Docket No. 52-021
MHI Ref: UAP-HF-10016

Subject: Amended MHI's Responses to NRC's Requests for Additional Information on Advanced Accumulator for US-APWR Topical Report MUAP-07001-P, Revision 2

**Amended MHI's Responses to NRC's Requests
for Additional Information**

**Advanced Accumulator for US-APWR Topical Report
MUAP-07001-P, Revision 2**

Fig. 36-1 1/2 scale Model of Flow Damper with full-height Standpipe

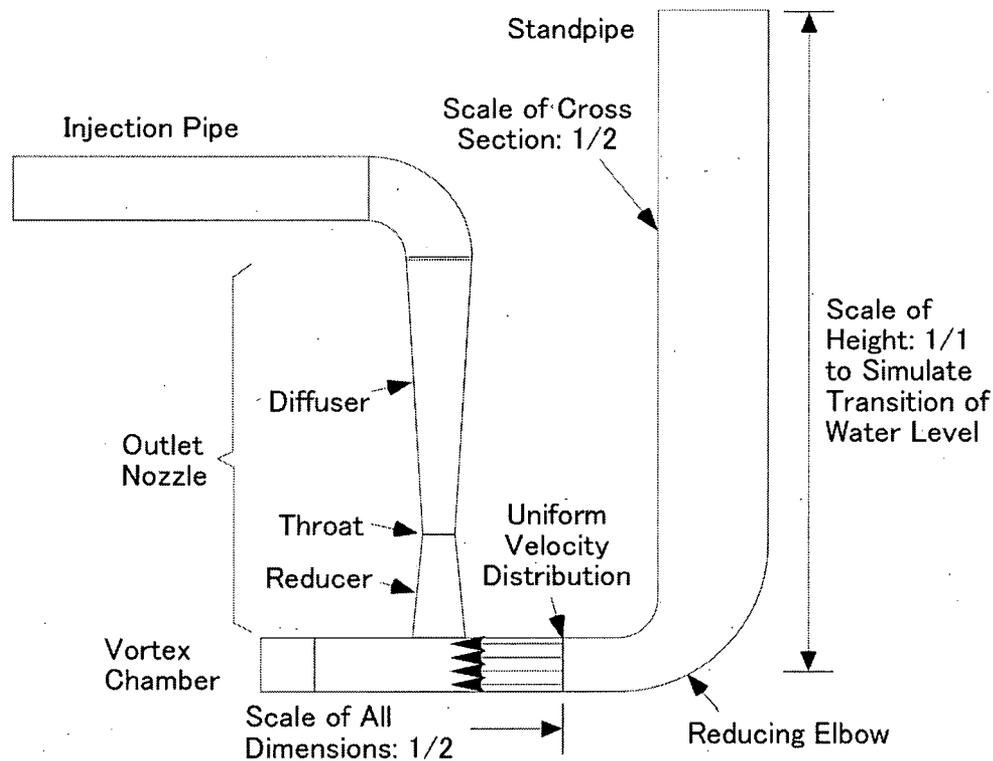
The accumulator characteristic correlations developed with the 1/2-scale accumulator test data indicate that the cavitation factor and flow rate coefficient are the only groups that represent important phenomena for high and low flow conditions.

(a) Are the cavitation factor and flow rate coefficient the only dimensionless groups that represent the important phenomena?

(b) In MHI's response to RAI 9-A (Sept, 2008), why is there no gravity term in the momentum equation? What are the boundary conditions (configuration)? What is the length scale (D) and the basis for being appropriate for all directions? Eq. 9-2 describes the local momentum balance. The statement below that Eq. states that the pressure loss is only function of Reynolds number. However, there is pressure loss beside the friction (viscous) loss that depends on the geometry. How is the pressure loss based on geometry preserved in different size facilities?

(c) Is the response for RAI 9-B (Sept, 2008) applicable to both large and small flow conditions? In case of gaseous cavitation (dissolved nitrogen), how do you calculate critical cavitation pressure.

(d) In the response to RAI 9-C, how are possible cavitation effects taken into account in the scaling assessment?

The states of flow in the full-height 1/2-scale model of the flow damper and the standpipe are shown in Fig. 36-1. The scale of all dimensions is 1/2 except the height of the standpipe. For large flow injection, the ratio of cross sectional areas of the standpipe and the large flow pipe is [] so that there is no flow separation in the elbow between them to make a uniform velocity distribution in the large flow pipe. (See "Handbook of Hydraulic Resistance," by I.E. Idelchik, pp.400-401, 4th Revised and Augmented Edition, Begell House, Inc., 2007) In other words, the length of the standpipe does not affect the flow in the flow damper. In addition to that, the inlet of the standpipe below the anti-vortex cap is designed to have configuration without flow separation so that flow in the standpipe is uniform. The ratio of cross sectional areas of the accumulator tank and the standpipe is [], so the flow toward the inlet of the standpipe is rapidly accelerated for which the accumulator tank serves as a reservoir where water is almost at rest. Consequently, flow at the inlet of the standpipe is not affected by the flow conditions in the accumulator tank but only by the gas pressure. Friction losses in the standpipe for both the actual accumulator and the full-height 1/2 scale model are less than [] of flow resistance of the flow damper and negligible. Friction loss in the flow damper was evaluated with the data of 1/5 and 1/2 scale models, and the scale effect to friction loss was confirmed to be negligible for the operating conditions of the advanced accumulator. It is because the length of the flow path in the flow damper is less than that of the standpipe in addition to high Reynolds number.

For flow switching, a water column in the standpipe is in one dimensional motion as in water hammer analysis. Since it has actual velocity, actual amount of undershoot of water level happens in the full-height 1/2-scale standpipe so that simulation of water level transition in the standpipe can be realized. This is the reason the full height standpipe was chosen for the 1/2 scale model.

flow switching. A water column in the standpipe is in one dimensional motion as in water hammer analysis, where the height of the standpipe affects the motion of the water column but the hydraulic diameter does not. Please see the Response to RAI 18, UAP-HF-08174-P(R0). Therefore, the height of the standpipe should be used for the Froude number. The height of the standpipe for the full height 1/2 scale model is the identical as for the actual one.

For small flow injection, flow in the standpipe stops, so flow in the flow damper of 1/2 scale model is similar to that in the actual one. At very last stage of small flow injection, water level in the accumulator tank approaches the small flow pipe after the safety injection pumps start and the accumulator tank ends its role.

The minimum cross sectional area of the flow path is at the throat of the outlet nozzle. The cross sectional areas of the standpipe and the accumulator tank are [] and [] times the minimum cross sectional area respectively. Their dynamic pressures are less than [] of that at the throat and negligibly small. Consequently, the flow resistance of the advanced accumulator can be determined by the flow resistance of the flow damper.

(a) Generally speaking, the dimensionless groups that represent the important phenomena are the cavitation factor, flow rate coefficient, Reynolds number and Froude number. Their roles are different from each other. Reynolds number represents effect of viscosity on flow resistance. Effect of viscosity is included in the flow rate coefficient which is less dependent on

Reynolds number in the plant operating conditions. Since water is isothermal, gravity affects only the boundary conditions at the free surface of water in the accumulator tank and the standpipe, and does not appear in the momentum equation. The cavitation factor directly affects the flow rate coefficient only when cavitation occurs.
